# **SERVICE LETTER NUMBER 178**

#### 8000 BAGGAGE COMPARTMENT TIE-DOWN

By: RCG			
Approved: JRS	Aircraft Makes/Model(s):	Float Model(s): 8000S 8000A	Note(s): Optional Compliance Service Letter P/N 1009447 ECO 25045
Date: 5/4/2017	Dehavilland DHC-3 Cessna 208 Series		
Rev: A

FIGURE 1: APPLICABLE BULKHEAD ASSEMBLIES

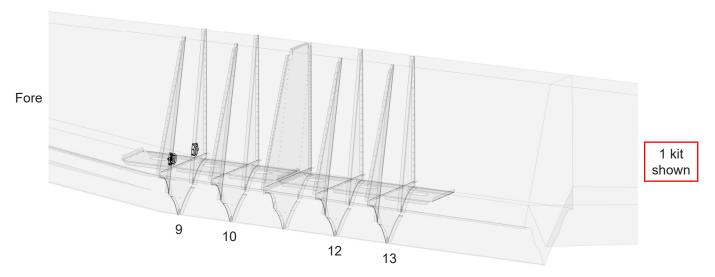
**NOTE:** 1 kit provides hardware to complete 1 bulkhead (inboard and outboard side). A total of 4 kits are needed to install tiedown rings at each bulkhead in both baggage compartments on 1 float. Reference figure 1.

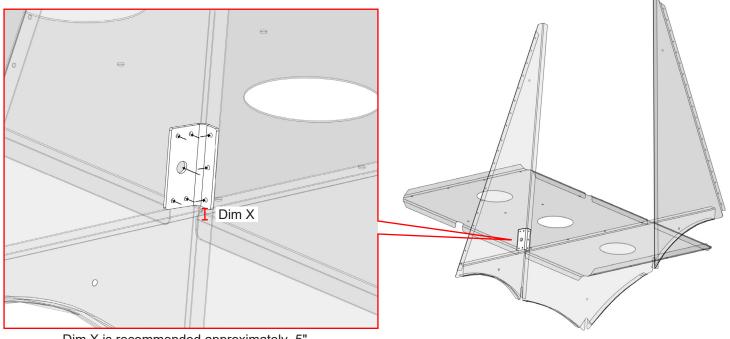
- 1. Gain access to bulkheads 9, 10, 12, and 13 through the top deck baggage doors
- 2. Match drill doubler 1009445 to fore side of bulkhead inside of flange as shown

Dim X is recommended approximately .5" from the bottom of the doubler to the top of the baggage floor but may vary per installer discretion

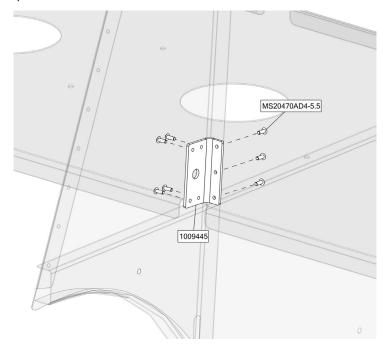
3. Rivet doubler 1009445 in place as shown

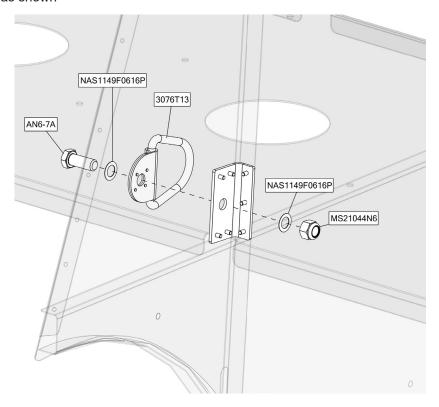
#### 4. Install tie-down kit as shown
